MINUTES
**BOARD OF BUILDING STANDARDS/
ARCHITECTURAL BOARD OF REVIEW/SIGN REVIEW**
REVIEW MEETING
CITY OF LAKEWOOD
12650 DETROIT AVENUE
AUDITORIUM
MAY 12, 2022
5:30 P.M.
RECORDING IS AVAILABLE
<https://www.lakewoodoh.gov/videos-2/>

Applicant proposes replacement awning and vinyl signage in the window and door. (Page 85)

Applicant proposes Design review of addition and renovation of an existing historic home. (Page 5)

Docket No. 03-08-22 (1464 Riverside)

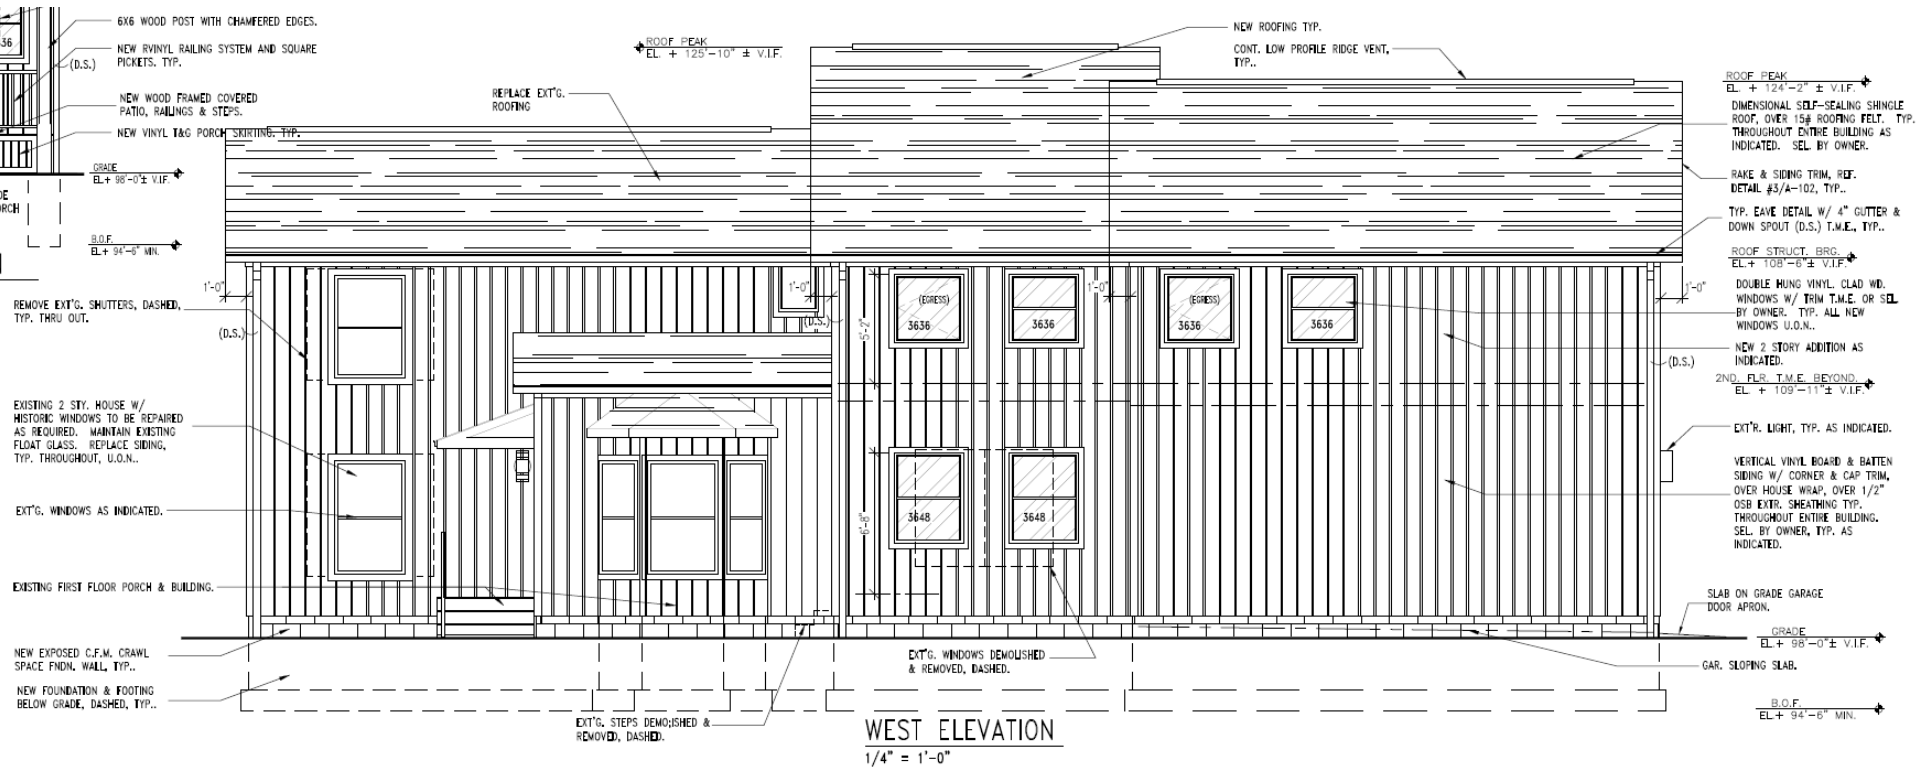
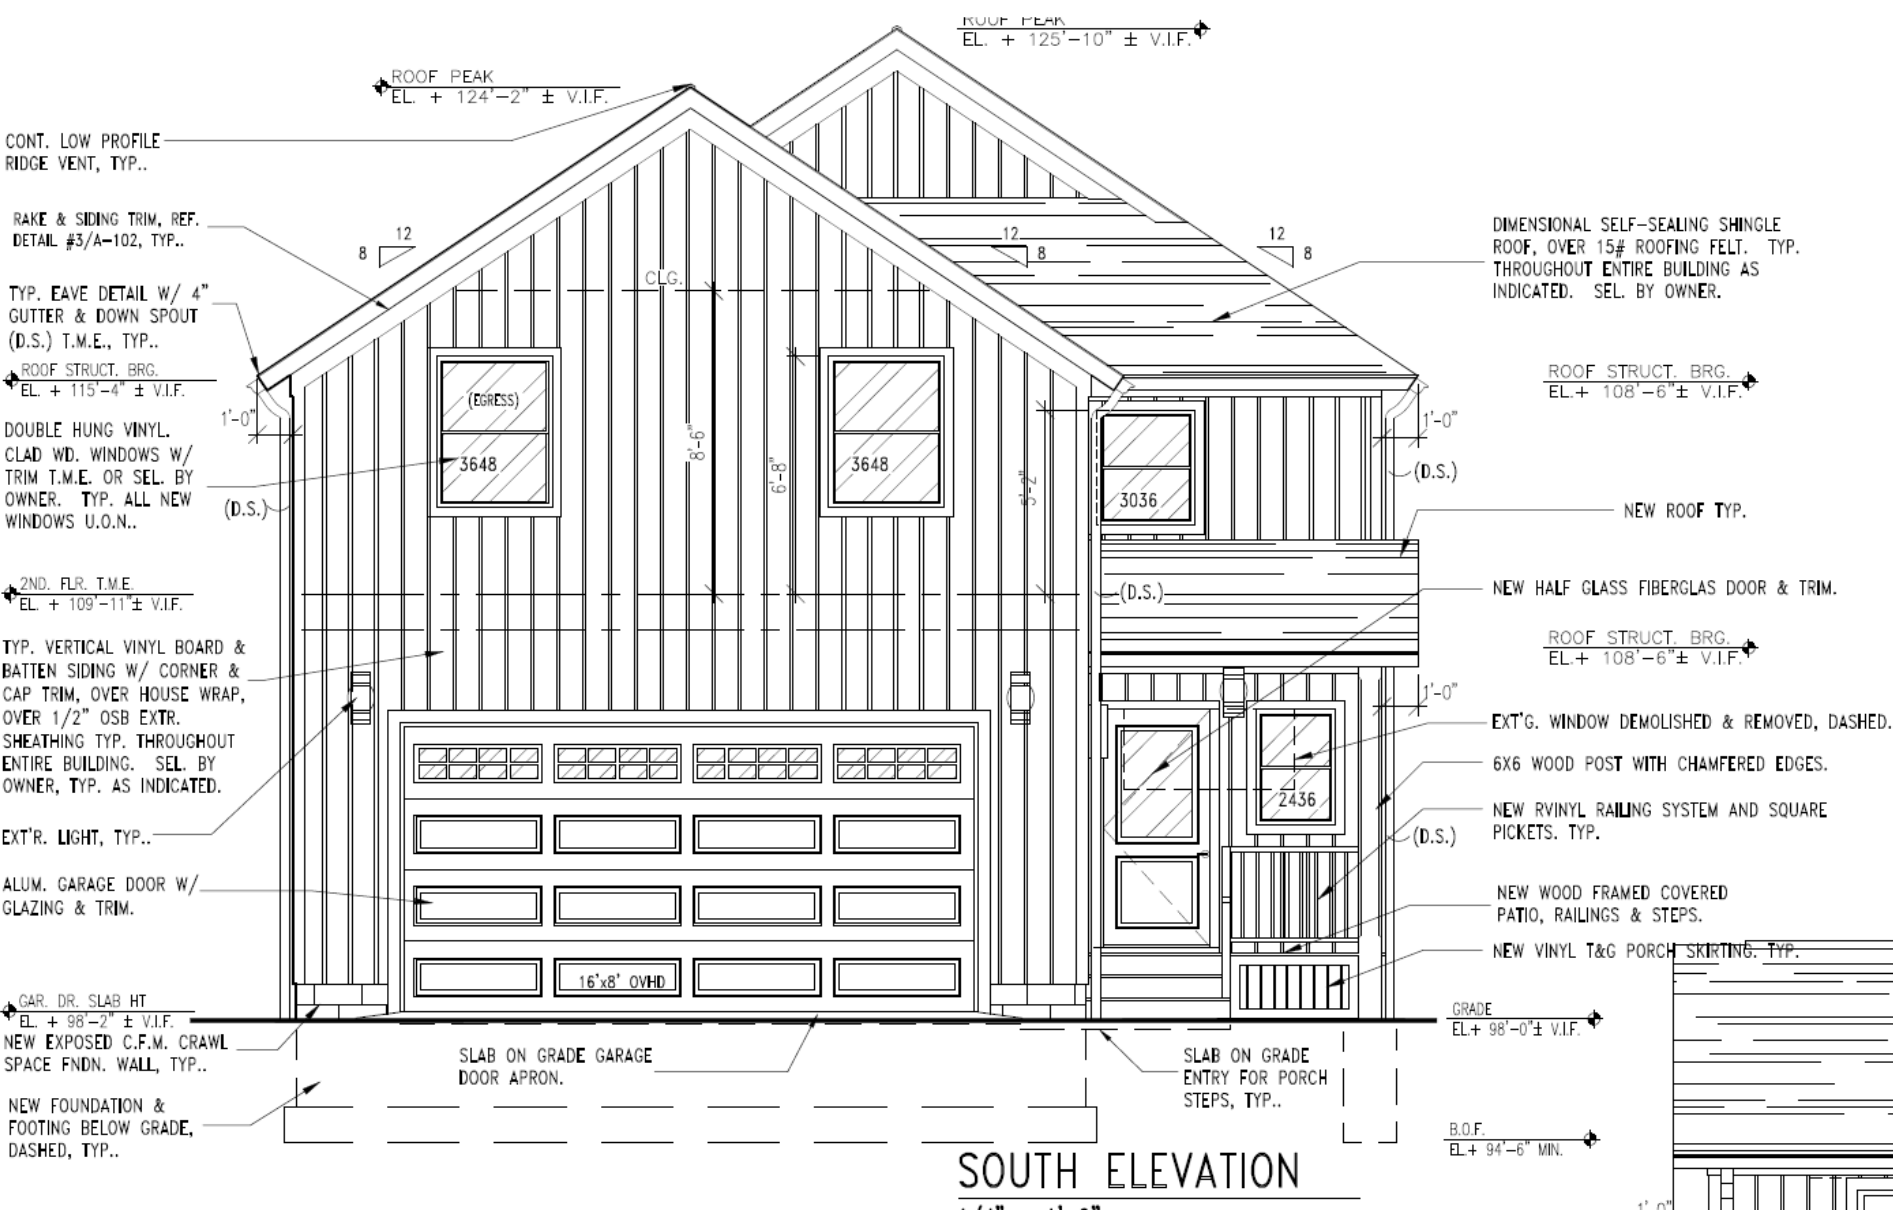
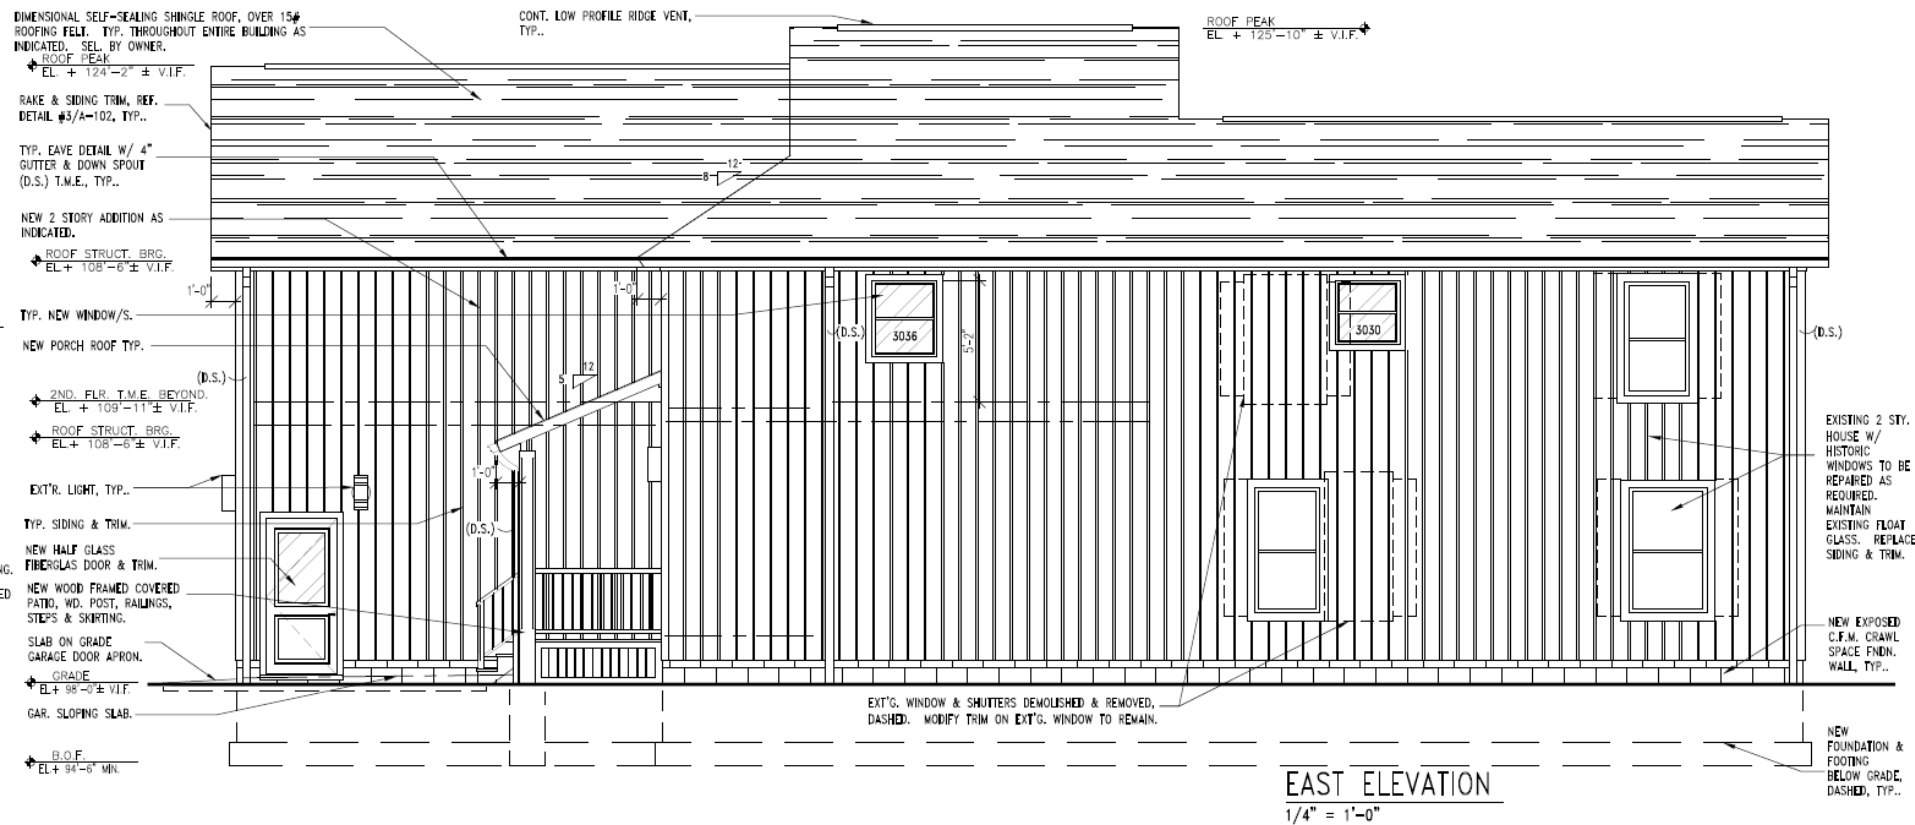
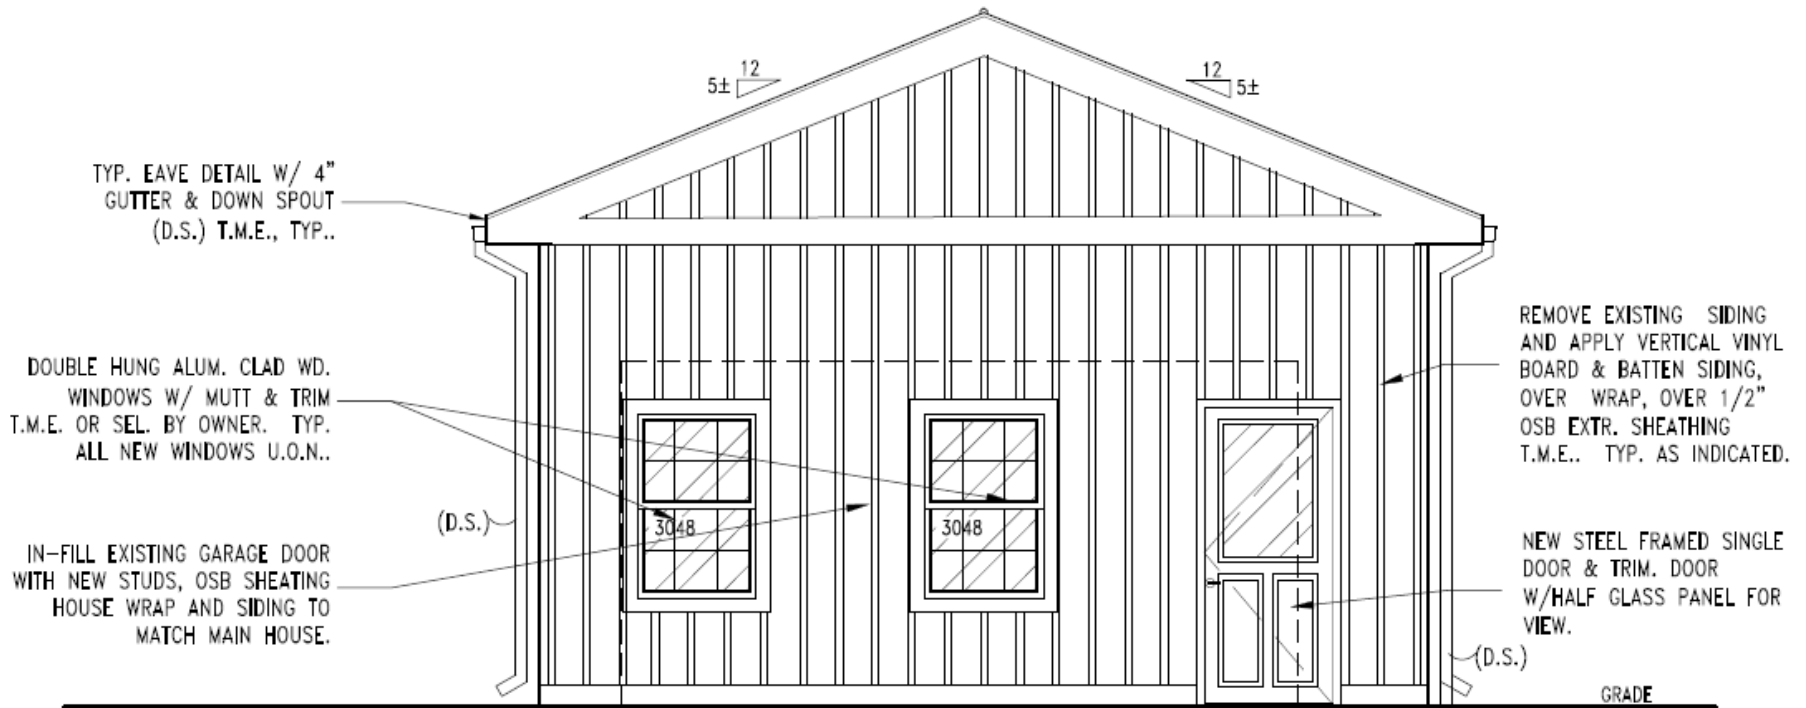
- *Provide updated elevations that reflect the current proposed material selections – including removal of shutters.*
- *Provide updated elevations for the accessory structure (garage) that reflect the new design elements/intent.*

- Provide updated elevations that reflect the current proposed material selections – including removal of shutters.
- Provide updated elevations for the accessory structure (garage) that reflect the new design elements/intent.

REMOVE EXT'G.
SHUTTERS,
DASHED, TYP.
THRU OUT.

Docket No. 04-19-22 (15319 Detroit)
Sign – Muddy Waters

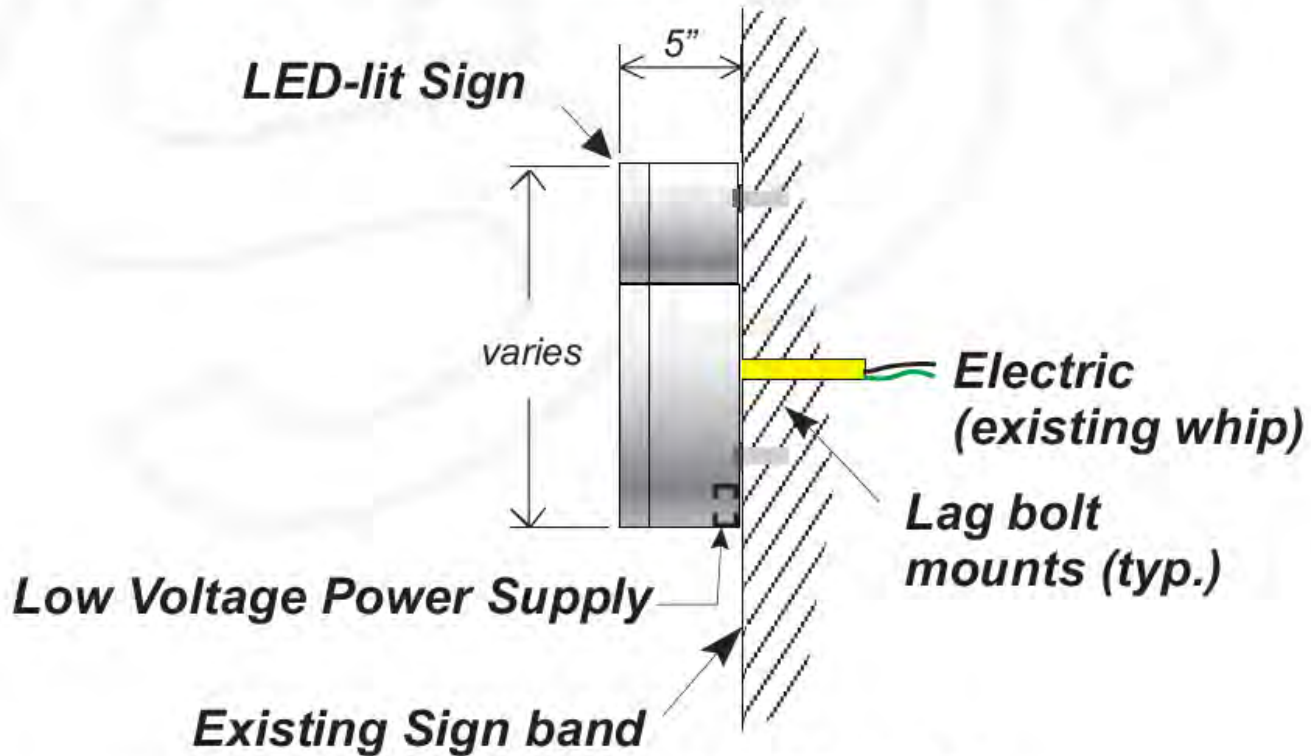
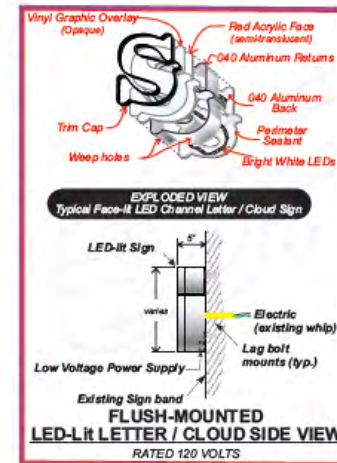
A motion was made by Mr. Maniet, seconded by Mr. Smith to **APPROVE** the illuminated sign is approved as presented and **APPROVE the window graphics request with the following condition:**

- Maintain the top one third of the window root graphics and raise the door graphic to be in line with the window graphic.

- Revision 4-11-22 :
 - a. Changed storefront to rectangular cabinet
 - b. Added rear vinyl decal to door window.
- Revision 4-26-22 :
 - a. Changed sign to curved top cabinet
 - b. Added pic of customer-applied vinyl
